ISSUED FOR s4.55(8)  
LODGMENT

DRAWING TITLE			PROJECT
COVER PAGE			VPM
SCALE	STATUS	NUMBER	REVISION
	s4.55 (8)	A0.00	A

S4.55(8) MODIFICATIONS

VPM  
9-11 VICTORIA PARADE, MANLY, NSW

DRAWING TITLE		PROJECT	
SIXTH FLOOR PLAN		VPM	
SCALE	STATUS	NUMBER	REVISION
1 : 100	s4.55 (8)	A1.08	A

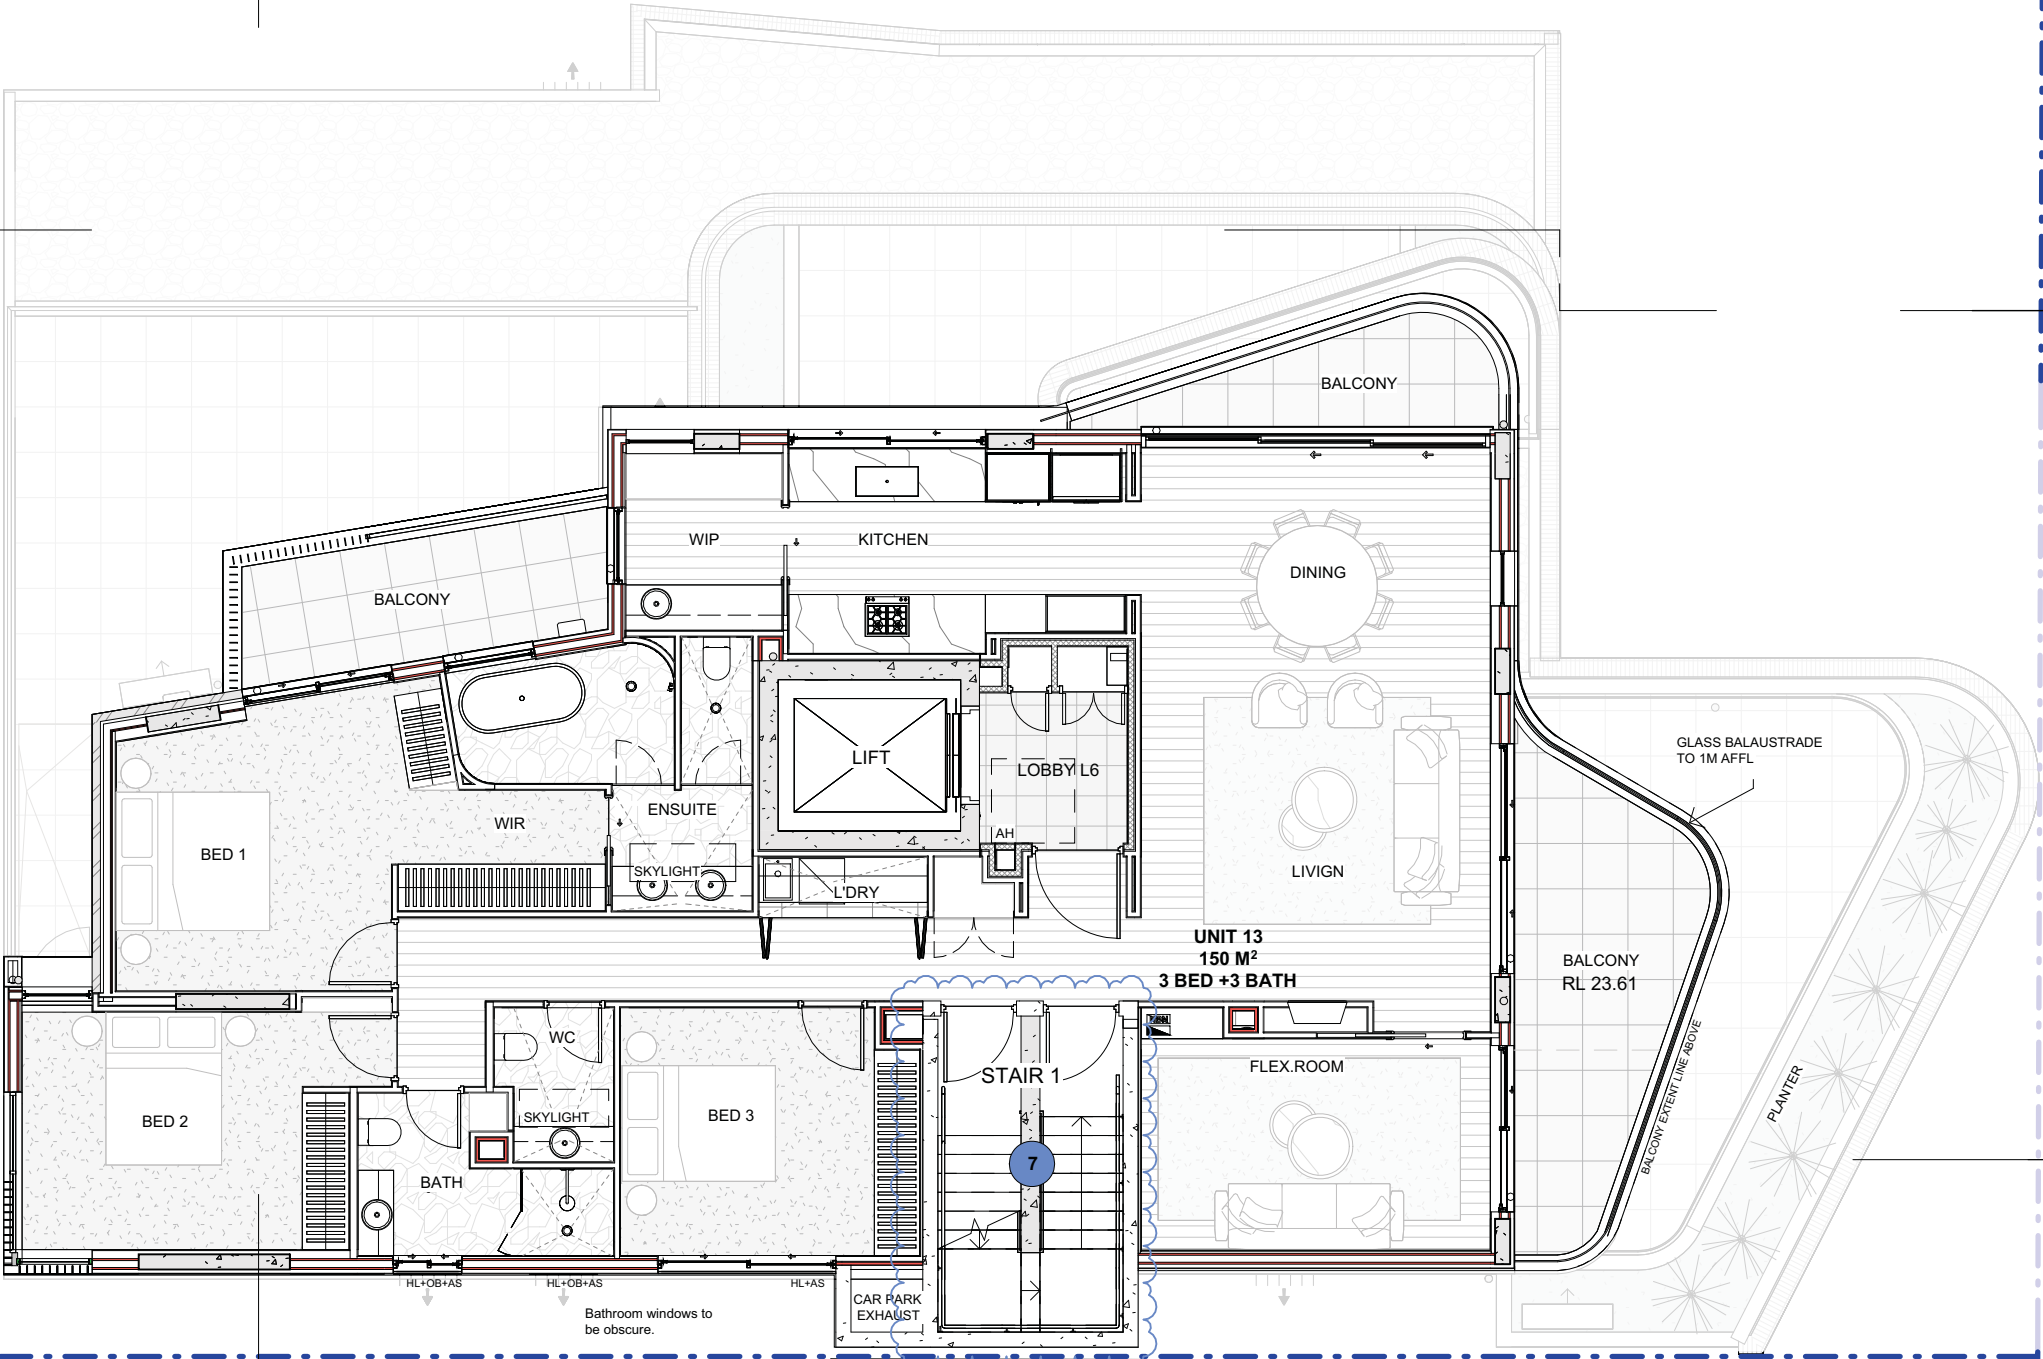
- Retail 1 on Ground floor has been pushed out to enhance the usable area and to suit new columns for balconies above.
- The front facade's angle has been adjusted to enlarge the front balconies and comply with ADG regulations of balcony size.

- Front balconies on level 1 and level 2 were extended to the north east to align with the approved balconies above to avoid looking 'top-heavy' and unbalanced.

- Level 4 brick wall shifted to align with adjacent brick walls.
- Cladding colour proposed to be off-white to visually lighten the bulk of the upper floors.

- Allocation of 1 bicycle space per unit in large storage cages in lieu of separate bicycle parking to satisfy the intention of condition 43D.
- Private roof terrace introduced to improve amenity of unit 14. The glass stair enclosure is not readily visible from the street and has no real impact on privacy, bulk or overshadowing.

- Increase in width of high-light windows to improve ventilation and natural lighting in the bedrooms with no privacy impacts.
- Minor adjustment to the GFA due to the above- still less than LEC approved FSR 3:1.

- Window heads have been lowered to 2.58m to fit services

DRAWING TITLE		PROJECT	
SOUTHEAST ELEVATION		VPM	
SCALE	STATUS	NUMBER	REVISION
1 : 100	s4.55 (8)	A2.01	A

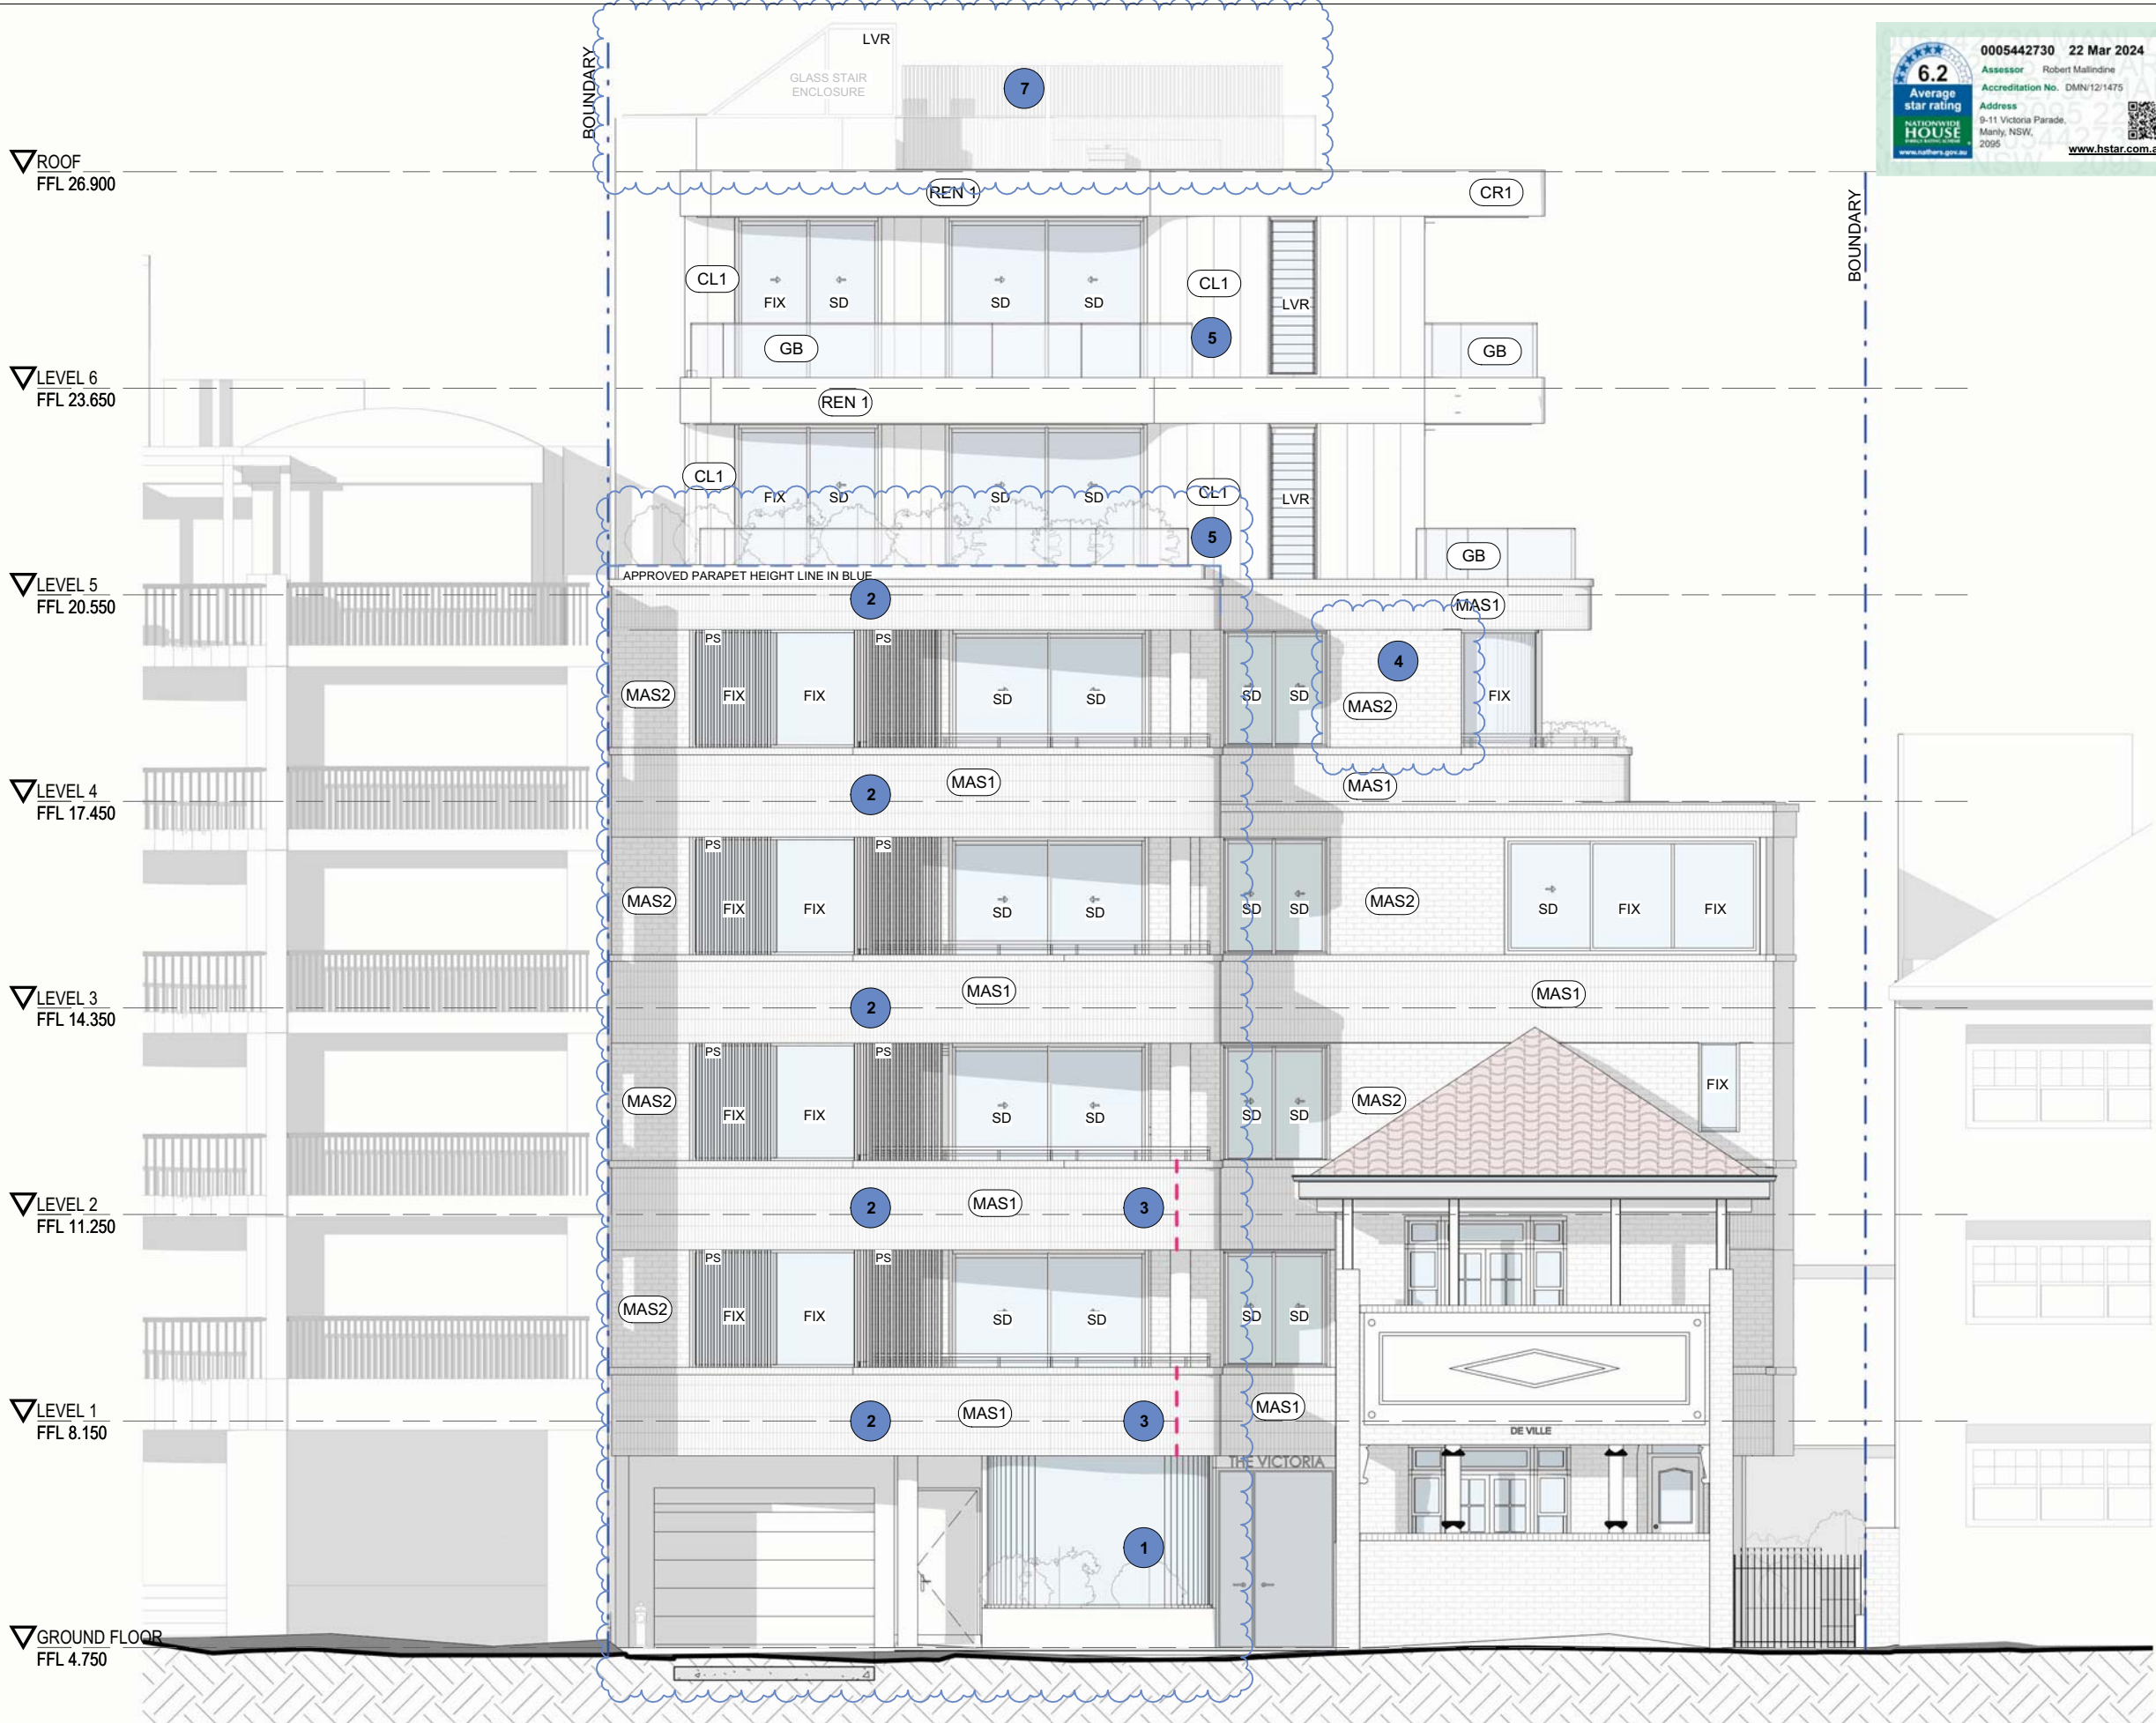
- PROPOSED S4.55(8) MODIFICATIONS LIST:**
- Retail 1 on Ground floor has been pushed out to enhance the usable area and to suit new columns for balconies above.

- The front facade's angle has been adjusted to enlarge the front balconies and comply with ADG regulations of balcony size.
  - Front balconies on level 1 and level 2 were extended to the north east to align with the approved balconies above to avoid looking 'top-heavy' and unbalanced.

- Level 4 brick wall shifted to align with adjacent brick walls.
  - Cladding colour proposed to be off-white to visually lighten the bulk of the upper floors.

- Allocation of 1 bicycle space per unit in large storage cages in lieu of separate bicycle parking to satisfy the intention of condition 43D.
  - Private roof terrace introduced to improve amenity of unit 14. The glass stair enclosure is not readily visible from the street and has no real impact on privacy, bulk or overshadowing.

- Increase in width of high-light windows to improve ventilation and natural lighting in the bedrooms with no privacy impacts.
  - Minor adjustment to the GFA due to the above– still less than LEC approved FSR 3:1.

- Window heads have been lowered to 2.58m to fit services

DRAWING TITLE  
SOUTHWEST ELEVATION  
SCALE STATUS NUMBER REVISION  
1 : 100 s4.55 (8) A2.02 A

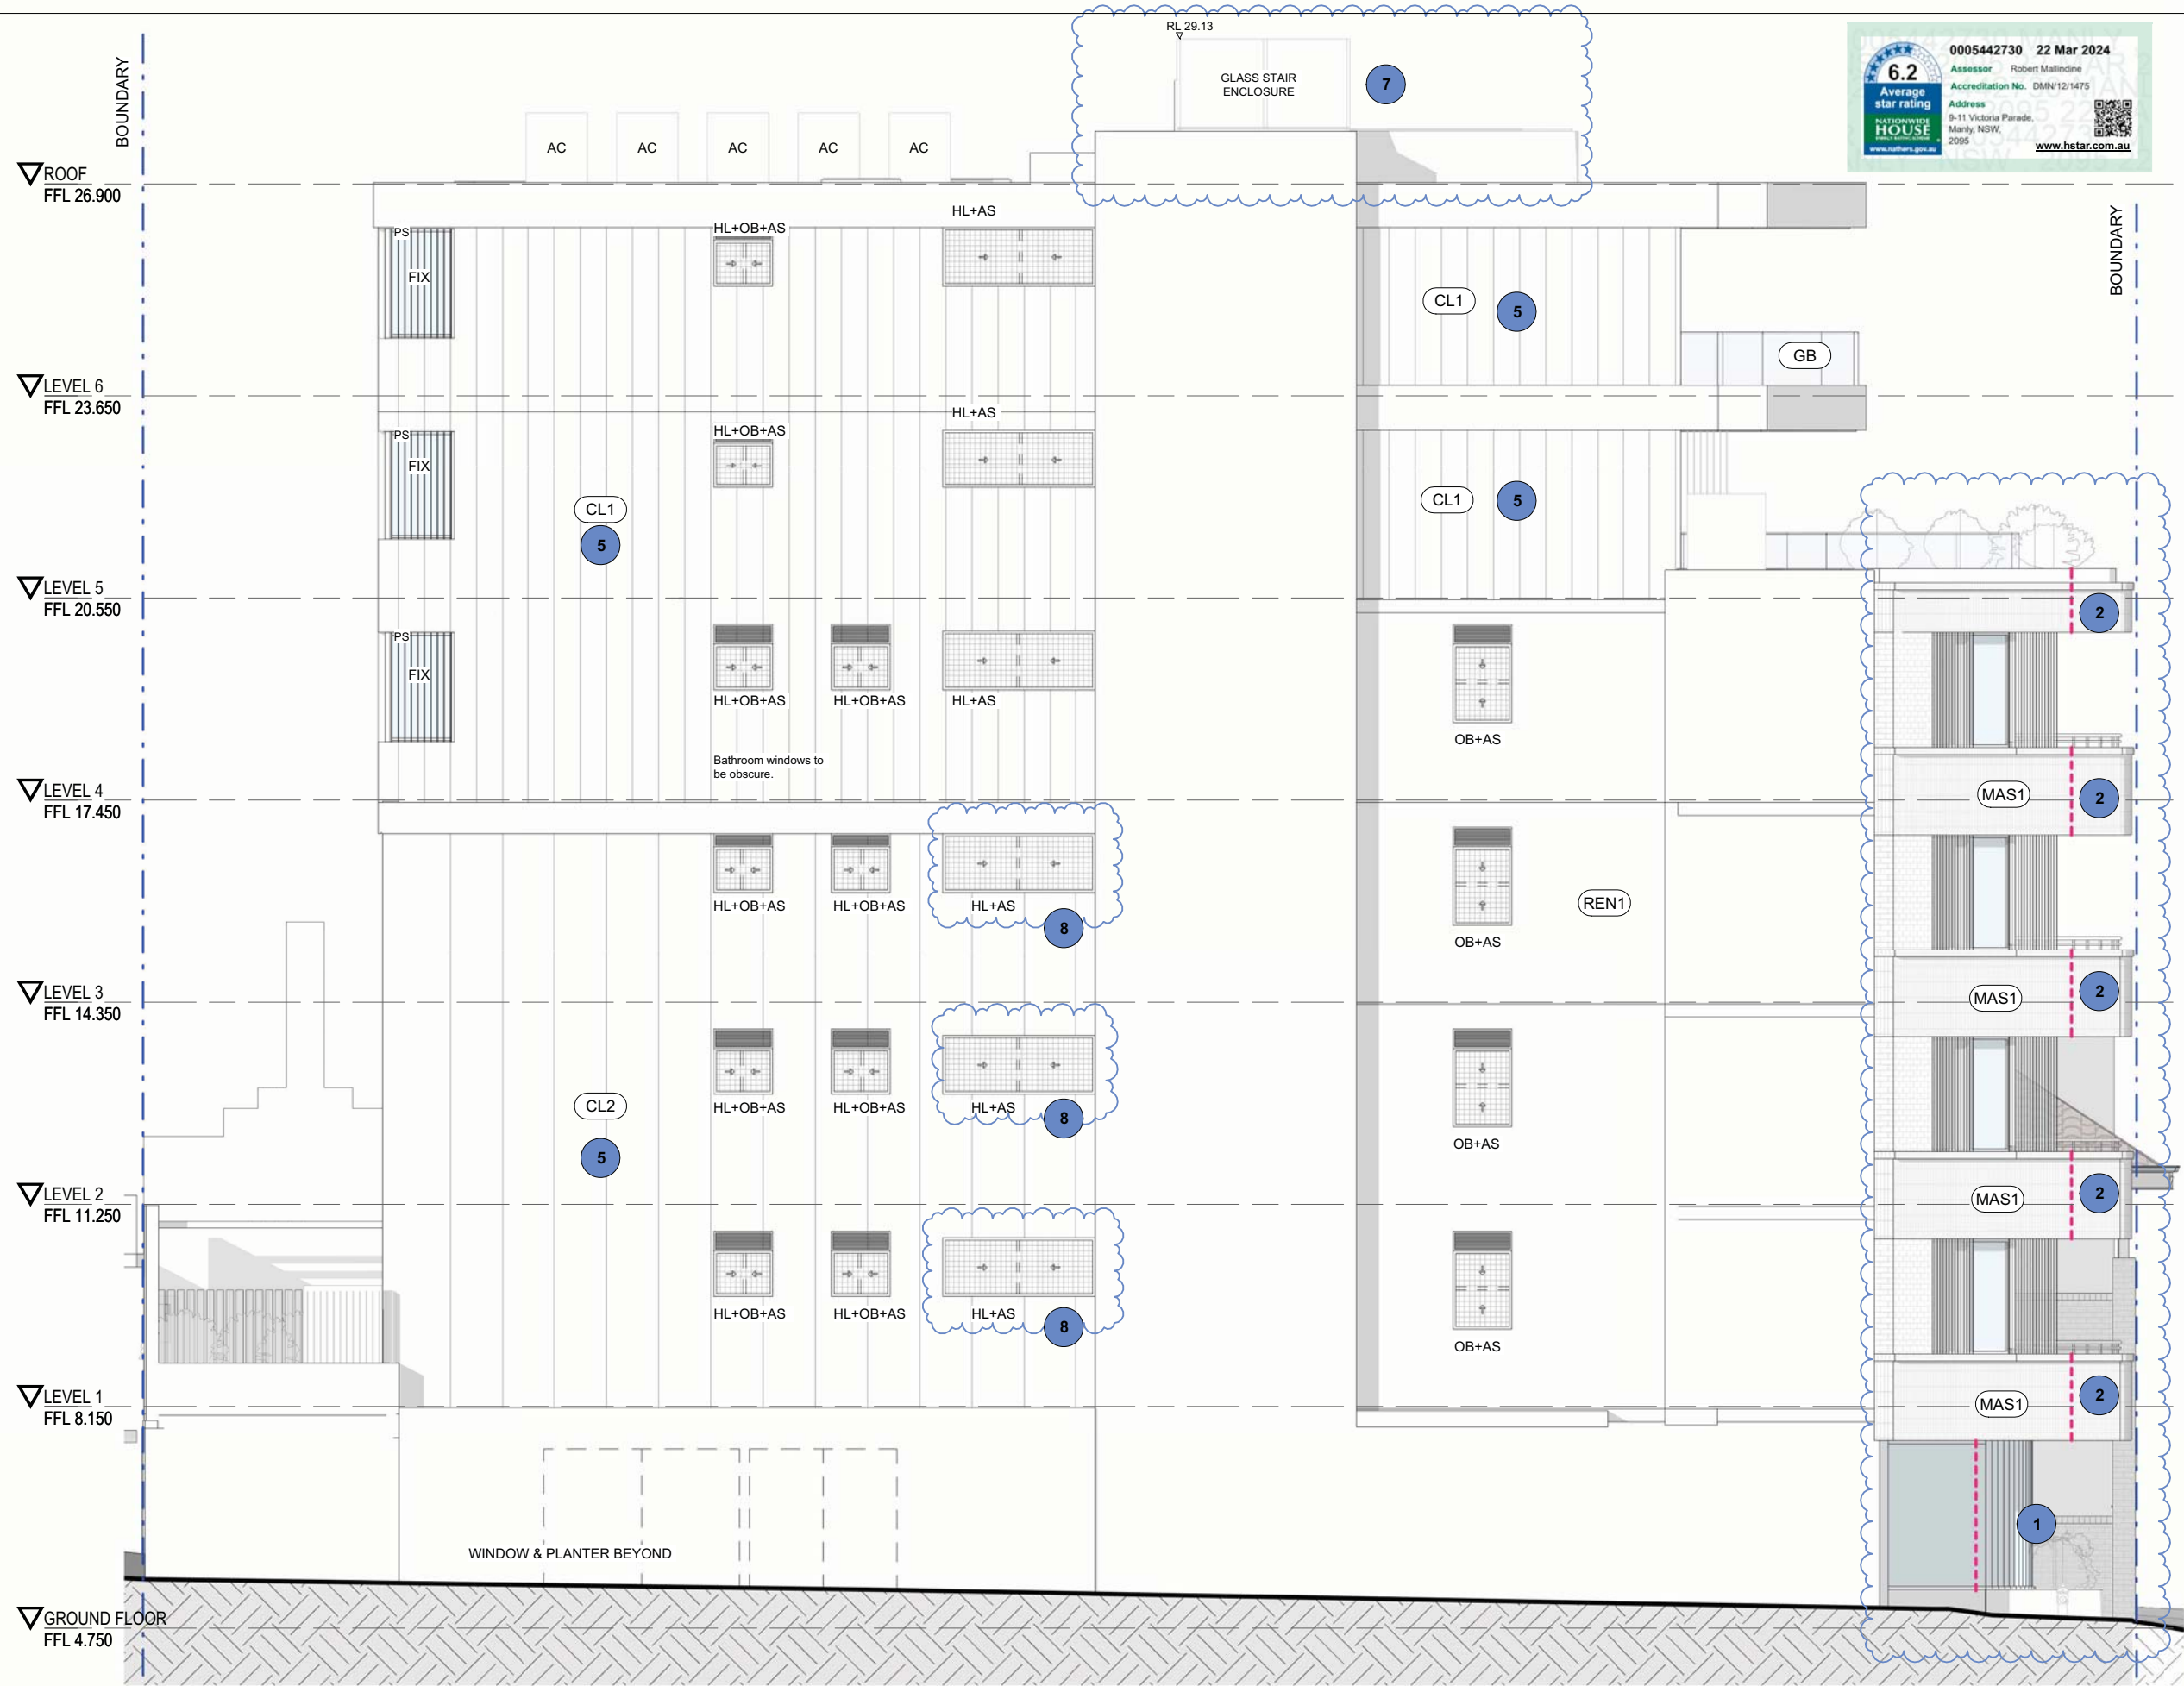
- Retail 1 on Ground floor has been pushed out to enhance the usable area and to suit new columns for balconies above.
- The front facade's angle has been adjusted to enlarge the front balconies and comply with ADG regulations of balcony size.

- Front balconies on level 1 and level 2 were extended to the north east to align with the approved balconies above to avoid looking 'top-heavy' and unbalanced.

- Level 4 brick wall shifted to align with adjacent brick walls.
- Cladding colour proposed to be off-white to visually lighten the bulk of the upper floors.

- Allocation of 1 bicycle space per unit in large storage cages in lieu of separate bicycle parking to satisfy the intention of condition 43D.
- Private roof terrace introduced to improve amenity of unit 14. The glass stair enclosure is not readily visible from the street and has no real impact on privacy, bulk or overshadowing.

- Increase in width of high-light windows to improve ventilation and natural lighting in the bedrooms with no privacy impacts.
- Minor adjustment to the GFA due to the above– still less than LEC approved FSR 3:1.

- Window heads have been lowered to 2.58m to fit services
